URGENT - Field Safety Notice

Hardware update of Patient Support (12NC 989001087431)

FSN MA-FCO 71200185

2018-April-23

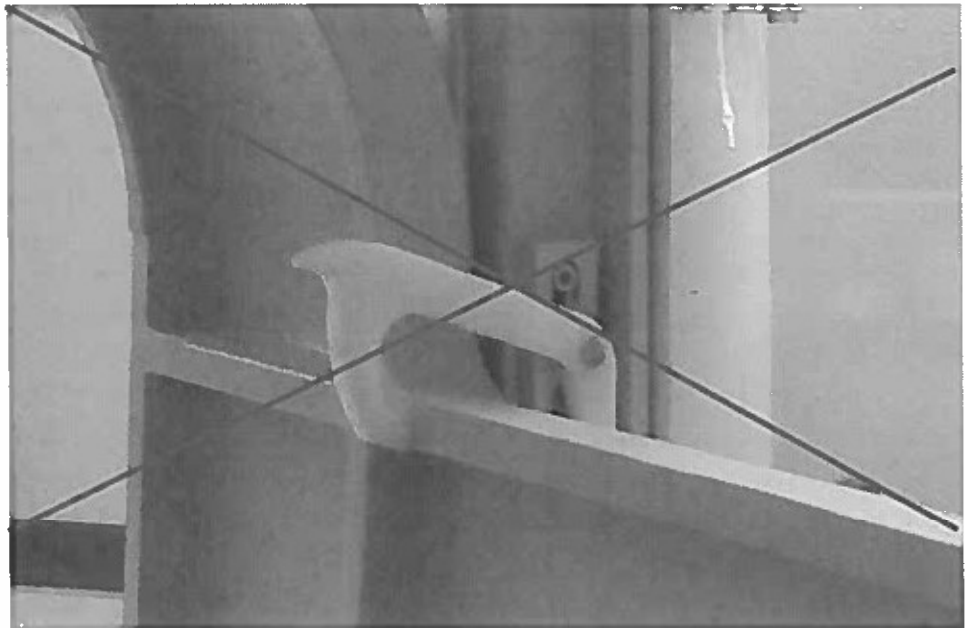
AFFECTED PRODUCTS	Patient support (NC989001087431)
PROBLEM DESCRIPTION	<p>The footplate of the Patient support for stitching can be fixed in upper position. When the fixing clamp (hook) is not in its correct locking position, the footplate is not securely held. If it falls down, it may hurt the operator's or patient's foot or leg (e.g. when moving the stand or when the operator fails to fix it correctly upon moving the footplate up).</p> <p>Following factors are needed that the situation occurs:</p> <ul style="list-style-type: none"> • Hinges are worn differently on both sides • Hook does not hold • Operator does not check that the hook securely holds the footplate • Footplate falls unexpectedly when touched or during transport • Foot or leg in "target area" <p>Foot in "hazard area"</p>
HAZARD INVOLVED	The hook does not securely hold the footplate in vertical position. Therefore, the footplate can fall or swing down and may hurt the operator or patient.

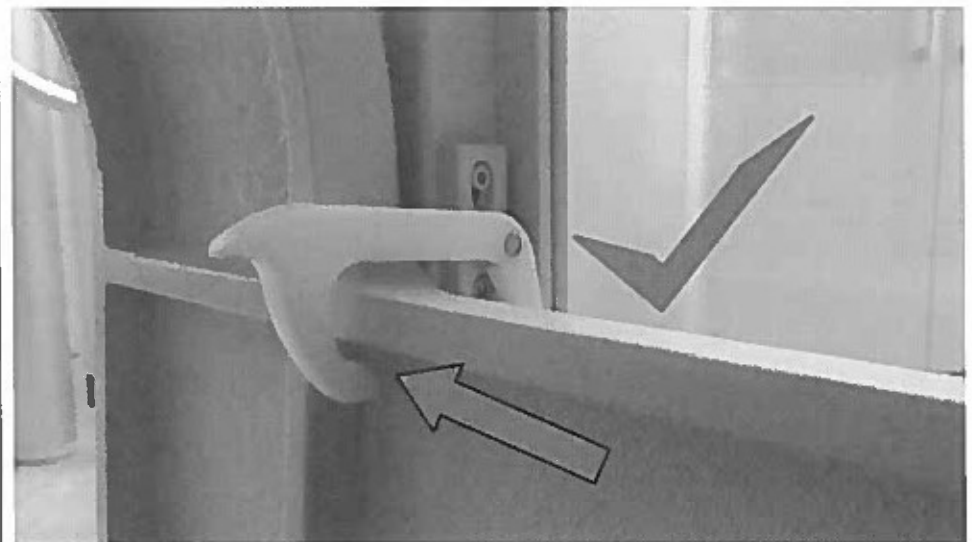
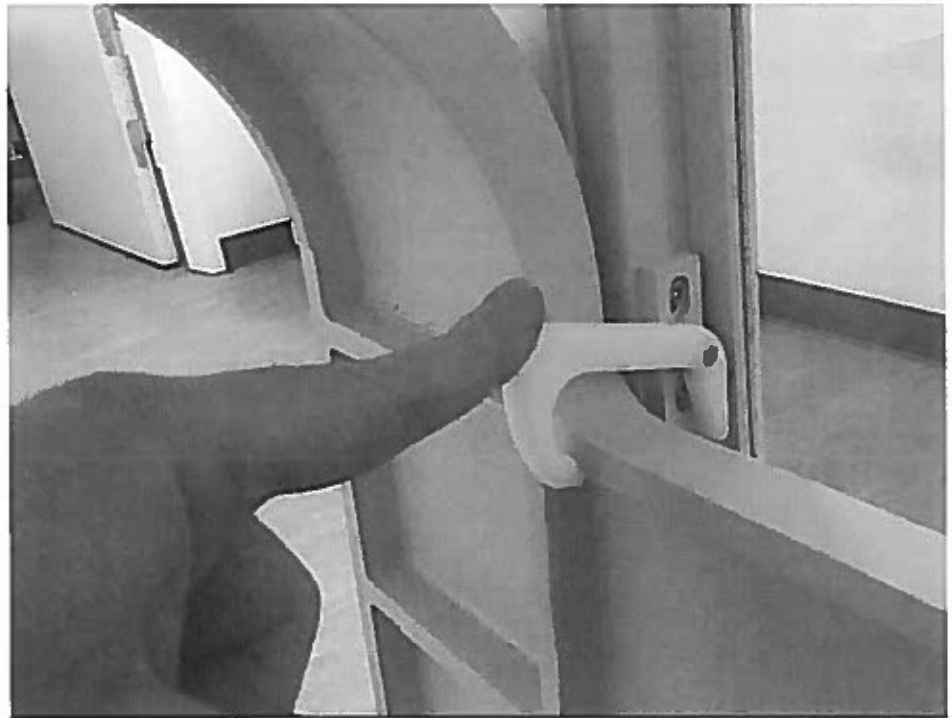
The customer / user should always check the right position of the hook and that the hook is locked according to IfU. (Press hook down until it is locked) Make sure that the hook is in position as shown in the picture with the green arrow

ACTIONS PLANNED BY PHILIPS	Philips plans to redesign the: <ul style="list-style-type: none">• sturdier replacement hinges for floor plate• install modified hook for floor plate (adapted to new hinges)• brake cylinder below floor plate to minimize kinetic energy <p>A Philips Service Engineer will contact you as soon as the Field Action Kit is ready to be implemented. Should you need to communicate with Philips in regards to this program, please reference FCO-71200185.</p>
FURTHER INFORMATION AND SUPPORT	If you need any further information or support concerning this issue, please contact your local Philips representative.
